NYN-01054

Seabrook Station
Inservice Inspection Program Revised and
New Relief Requests for ASME Section XI Requirements

Seabrook Nuclear Power Station Unit No. 1
Relief From Inservice Inspection Requirements
IR-1, Revision 1

REV	DATE	DSGN	DRWN	CHKD	CE	LDE	ISSUED	DESCRIPTION
New Hampshire Yankee								
EXCESS LETDOWN HEAT EXCHANGER 1-CS-E-3 ISI EQUIPMENT WELDS								
SEABROOK STATION								
FF-50252	06		EXCESS LETDOWN HX.					
REF. DRAWING NO.	REV		TITLE

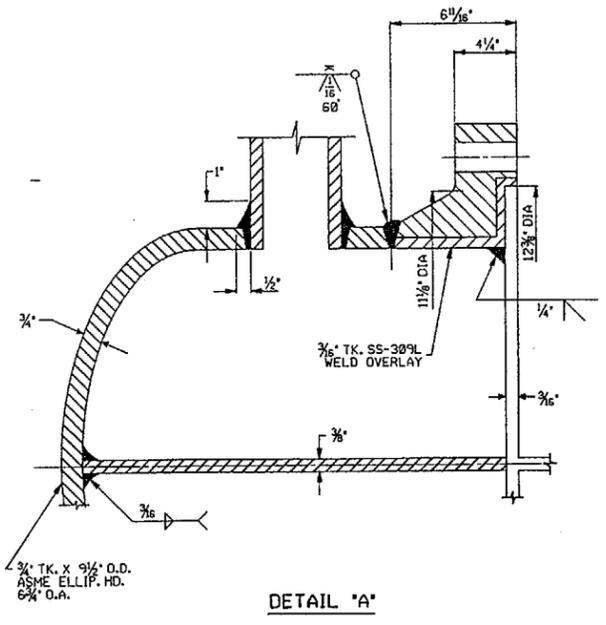
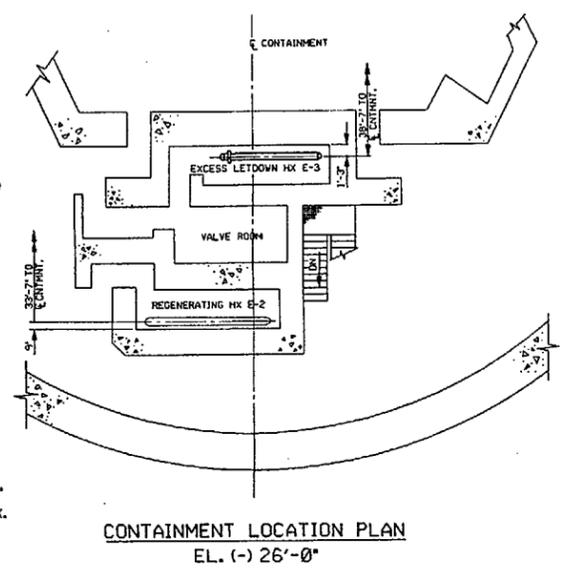
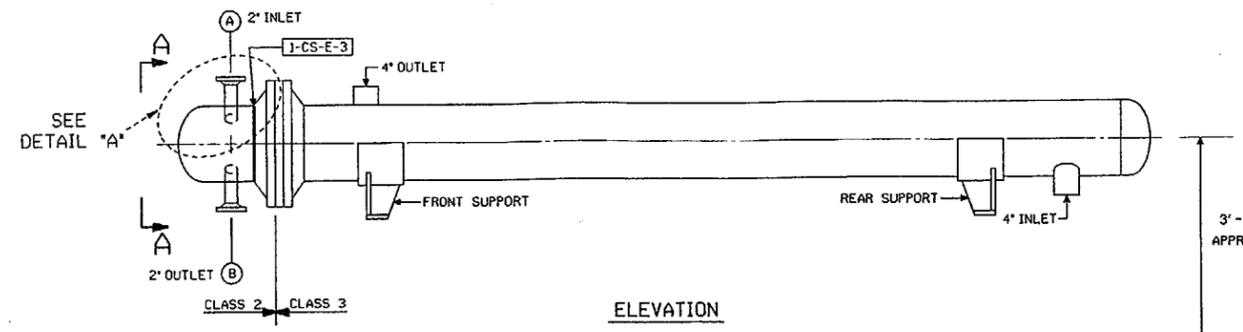
The examination requirement of "essentially 100%" of the weld length as specified in Table IWC-2500-1 Category C-A, Item No. C1.10 for weld CS E-3 C is impractical to meet. The examination coverage of this weld is limited to 43% due to vessel head to flange geometry and permanent physical obstruction. As depicted on drawing 1-NHY-650000 (Refer to Enclosure 2), the heat exchanger head is directly welded to a flange. The inlet and outlet connections are located on the head, but adjoin the weld. This creates a limitation such that the transducers can only scan from the head side of the weld and can only cover the area between the inlet and outlet connections.

Coverage for Excess Letdown heat exchanger weld CS E-3 C was conducted to the maximum extent practical with the design geometry and obstructions in place and is representative of the entire weld. This weld is also subject to VT-2 visual examination each inspection period as specified in Table IWC-2500-1, Examination Category C-H of the 1983 Edition through the Summer 1983 Addenda of ASME Section XI. The coverage obtained on this weld and the associated pressure testing performed provides reasonable assurance of continued structural integrity of this weld.

REV	DATE	DSGN	DRWN	CHKD	CE	LDE	ORIGINAL ISSUE	DESCRIPTION
New Hampshire Yankee								
ISI EQUIPMENT WELDS STEAM GENERATOR RC-E-11A								
1-NHY-650011								
FP-58218	19	OUTLINE-R.C. PUMP		TITLE				
REF. DRAWING NO.	REV	TITLE

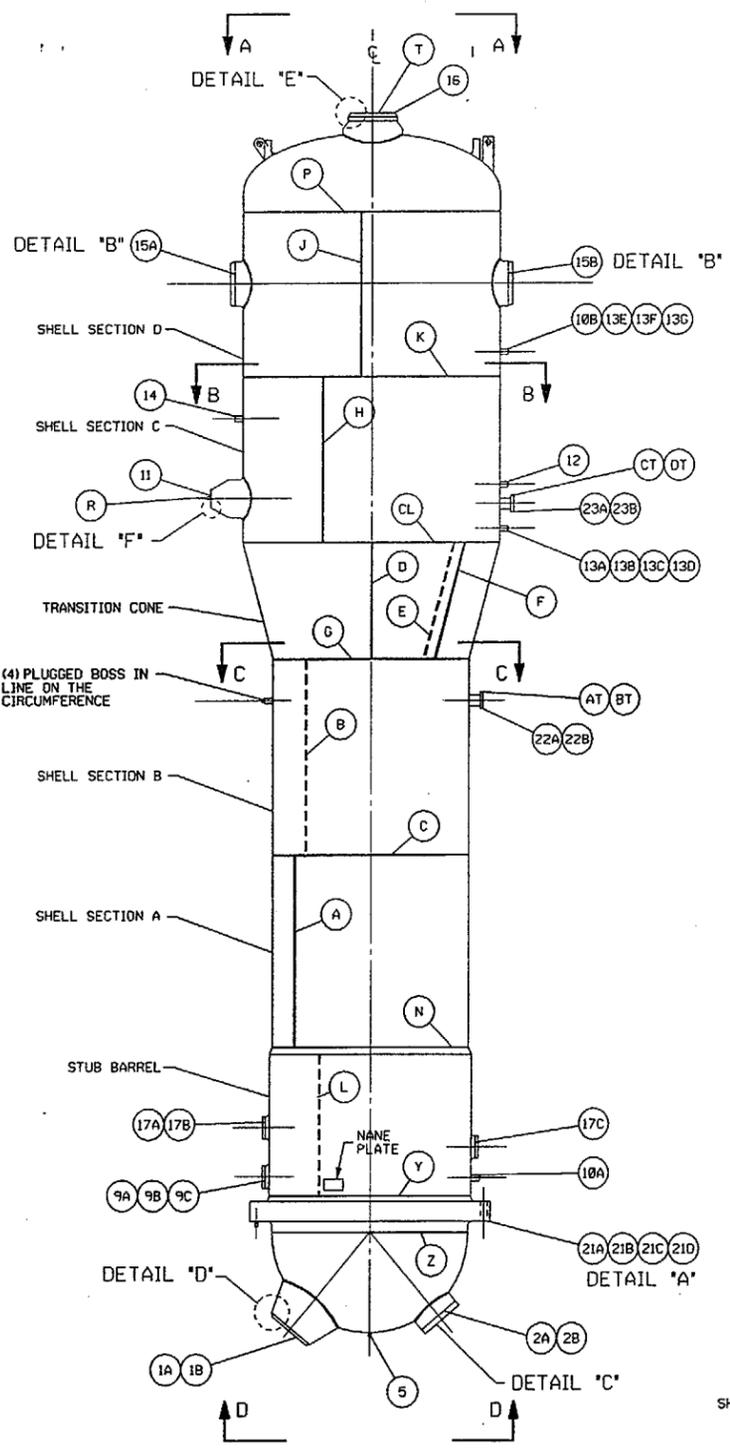
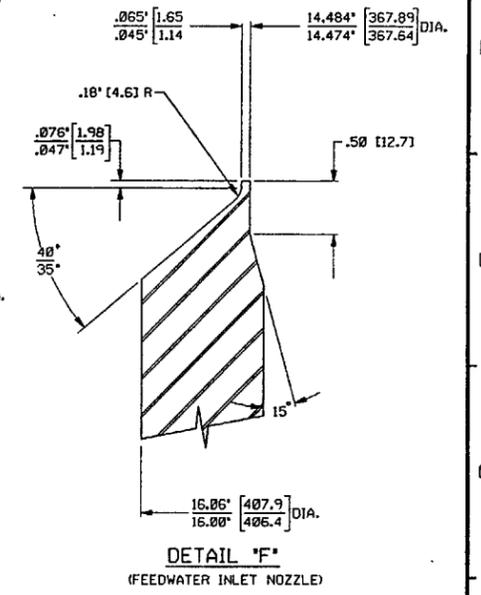
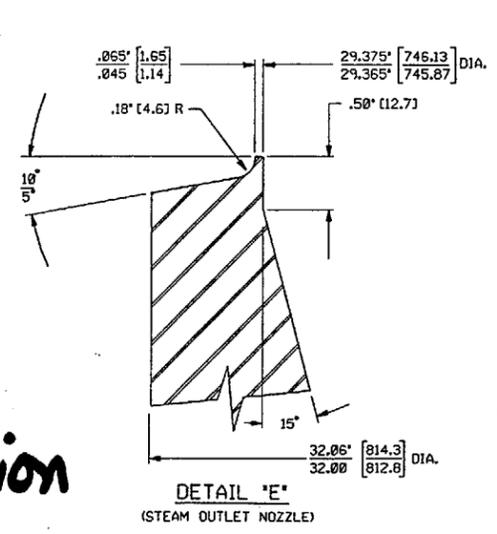
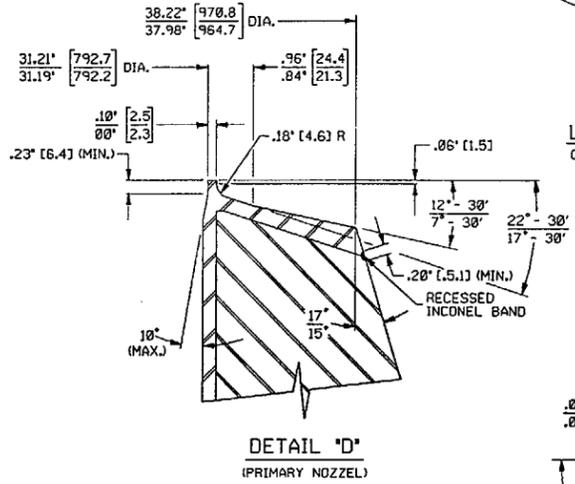
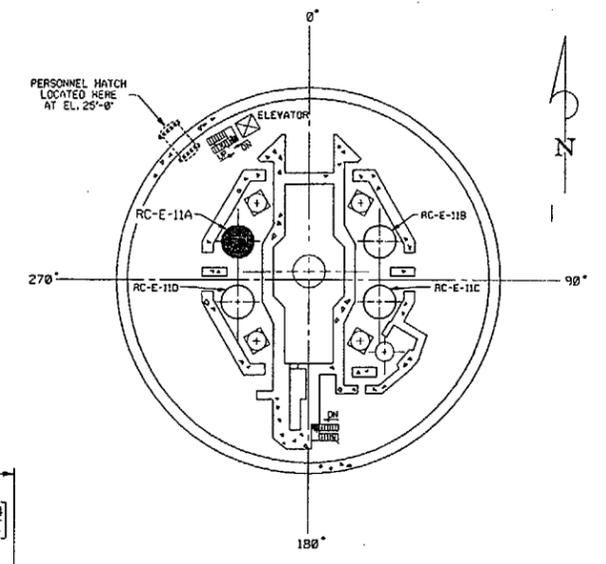
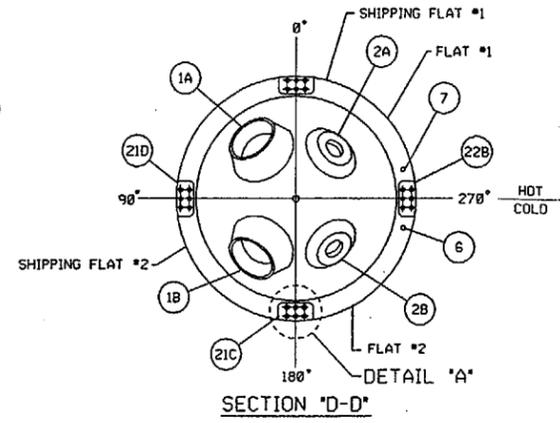
As required by ASME Section XI, Table IWB-2500-1, Category B-B, requires this weld be examined volumetrically for essentially 100% of the weld length. Weld RC E-11A SEAM-1 can not be examined for essentially 100% of the weld length due to design (physical obstruction from four steam generator supports). ISI Drawing 1-NHY-650011 (Refer to Enclosure 2) shows the four steam generator support pads. These pads are approximately 18” in length and block access to this weld in four locations. These obstructions limit the weld examination volume to 78%. This was the maximum extent achievable.

As required by ASME Section XI, Table IWB-2500-1, Category B-D, these welds receive a volumetric examination. Welds RC E-11A 2A-NZ and RC E-11A 2B-NZ have limited coverage due to the nozzle to shell geometry and the ID cladding. The small distance between the nozzle and the weld does not provide sufficient room for the ultrasonic transducer to interrogate the Code required volume of these welds. In addition, the internal cladding causes the sound to reflect back to the transducer at the base metal to cladding interface, which further reduces examination volume. The maximum achievable coverage for both of these welds is 84%. The examination volumes achieved are the maximum extent practical. It is the North Atlantic position that the achievable examination volumes are representative of the entirety of each nozzle weld.
